**TOWN OF OCEAN RIDGE
PLANNING & ZONING REGULAR MEETING
AGENDA**

To:	Planning & Zoning Board Members
From:	Corey O’Gorman, Town Planner
Meeting Date:	July 21, 2026
Subject:	5920 N Ocean Blvd – Development Plan Review

PLAN REVIEW REPORT
5920 N Ocean Boulevard
05/06/2026 – 06/04/2026 – 07/14/2026

ASIR RESIDENCE
MAY 2026 TOWN PLANNER COMMENTS — COMPLIANCE RESPONSE
03 / 08

Sheet: new site plan

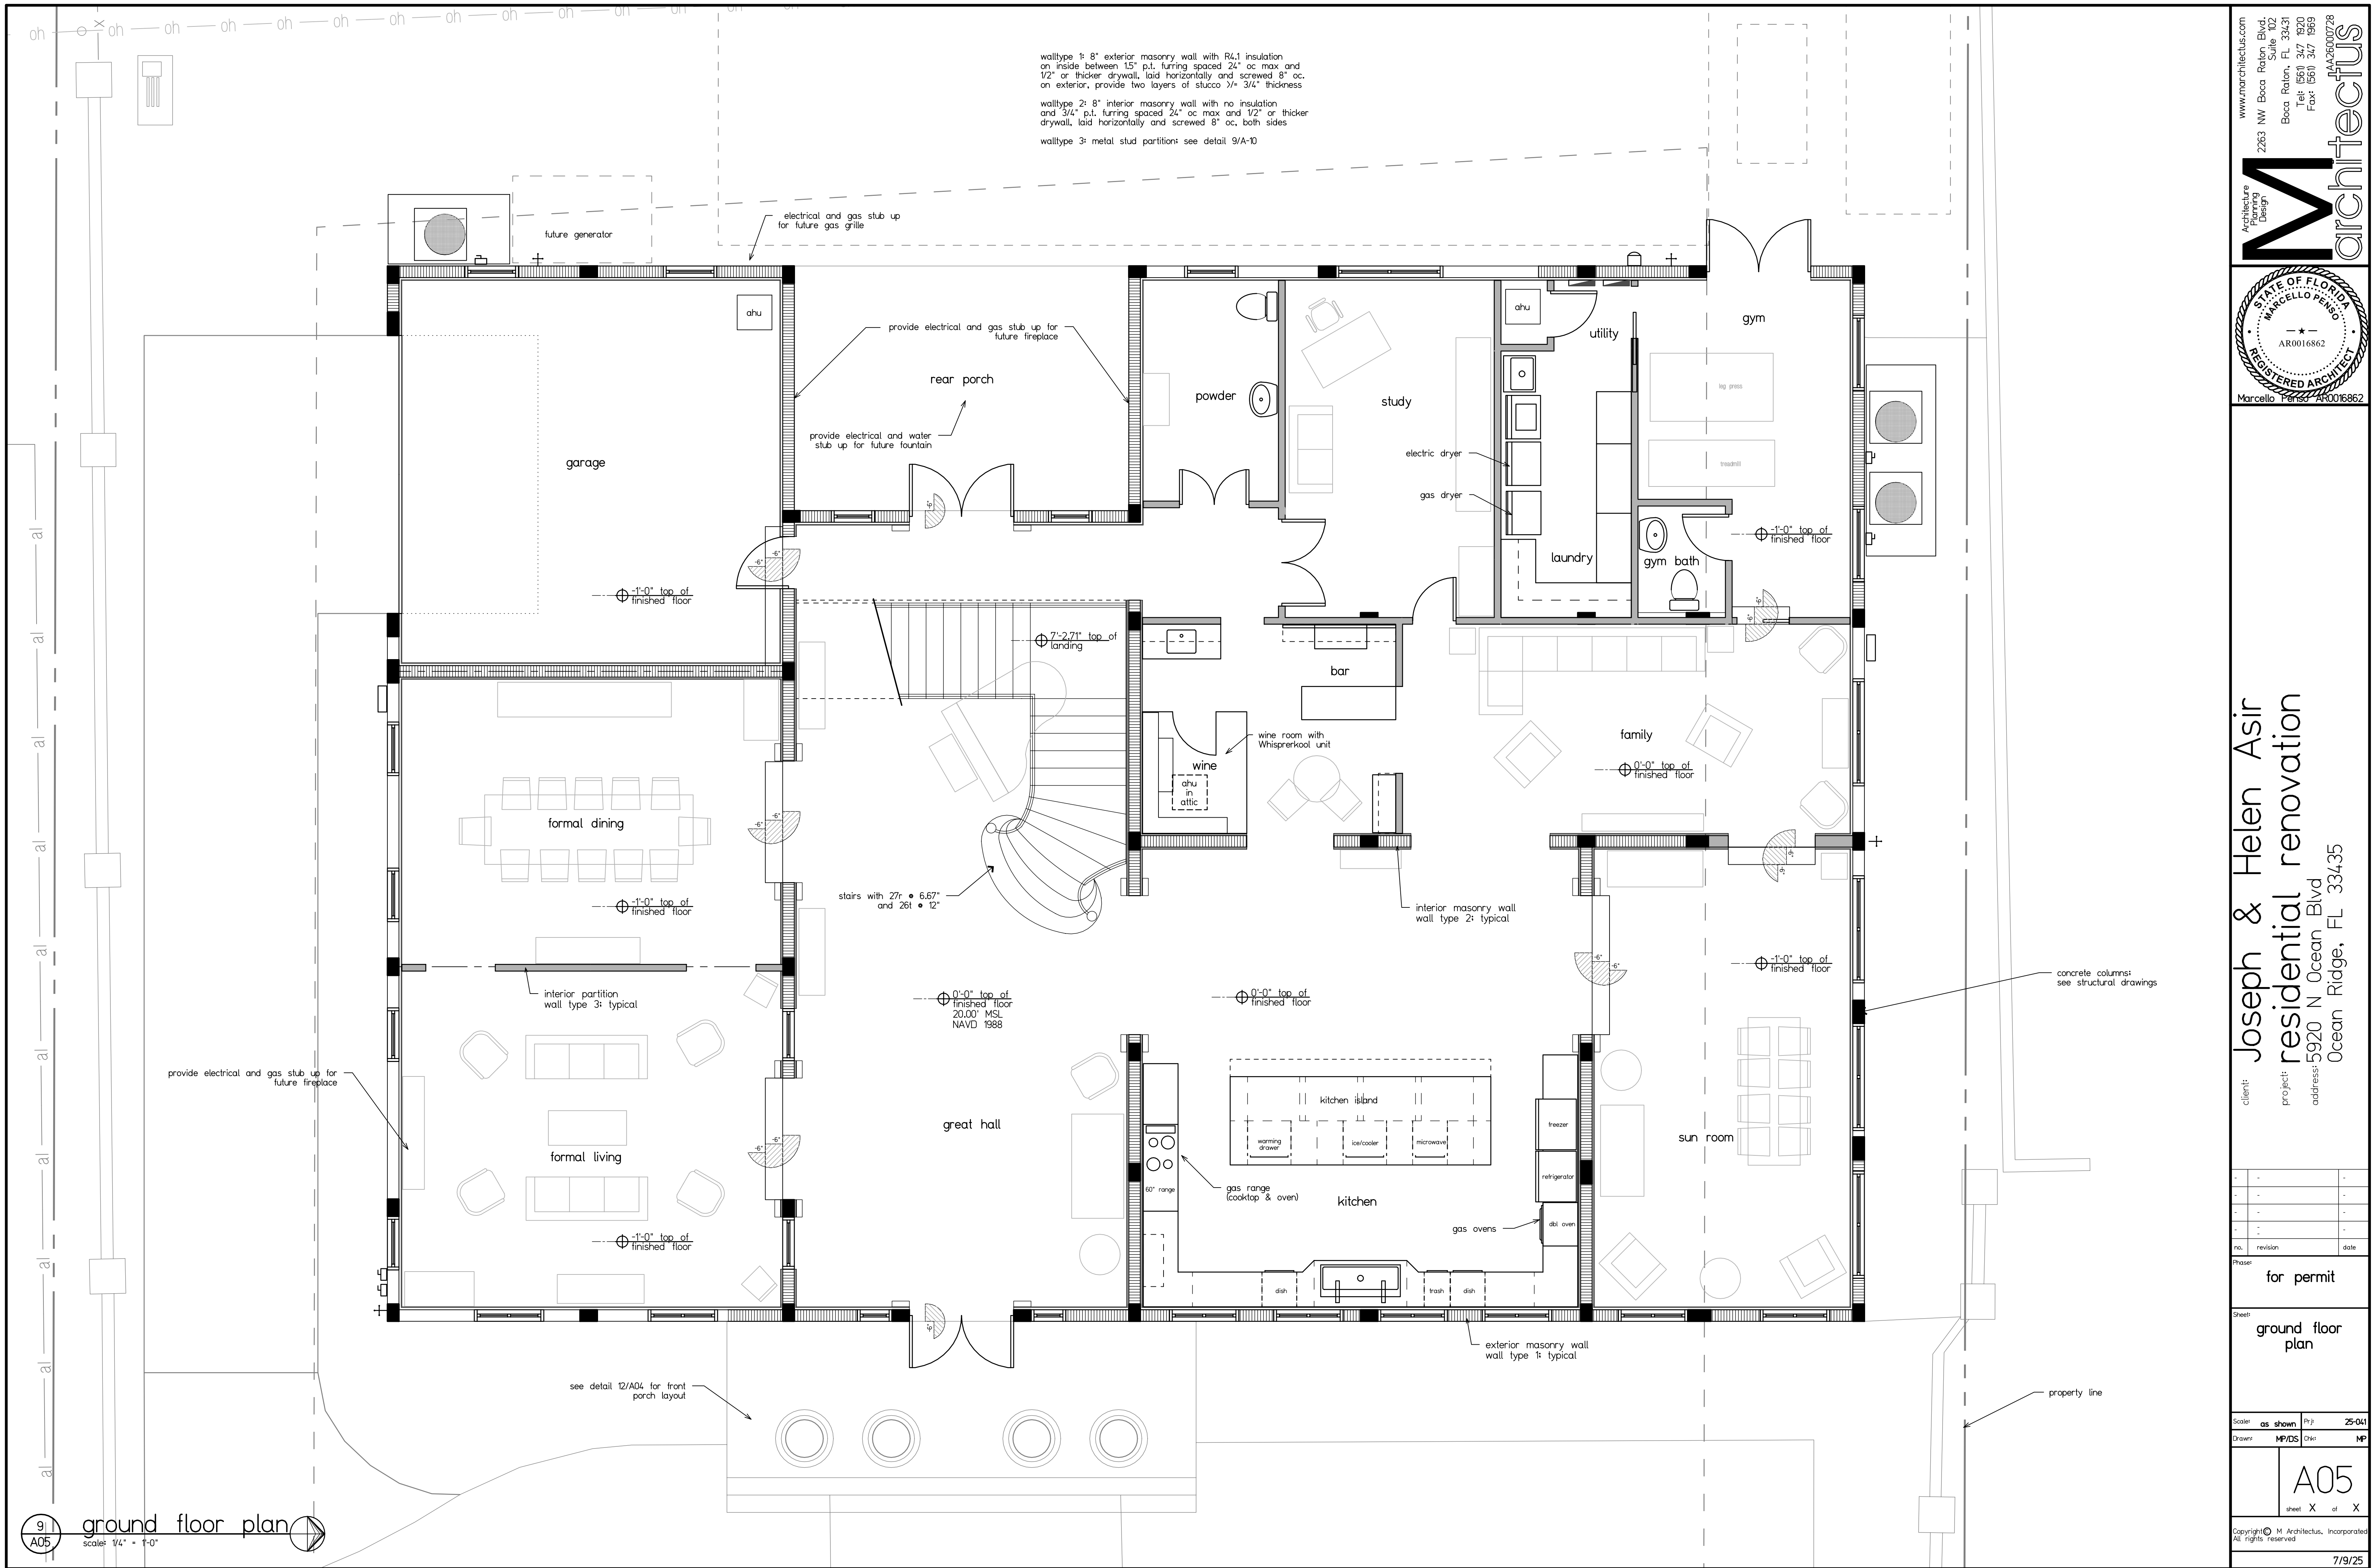
~~Comment: Please revise sheet A05 to show two parking spaces dimensioned at 10 x 20.~~ **Comment addressed.**

Sheet A05 revised to show two enclosed garage spaces dimensioned at 10'×20'. Air handler unit is ceiling-hung (noted on plans). Three exterior spaces at 9'×18' are shown on site plan. Total: 2 covered + 3 open = 5 spaces. Compliant for a 5-bedroom dwelling.
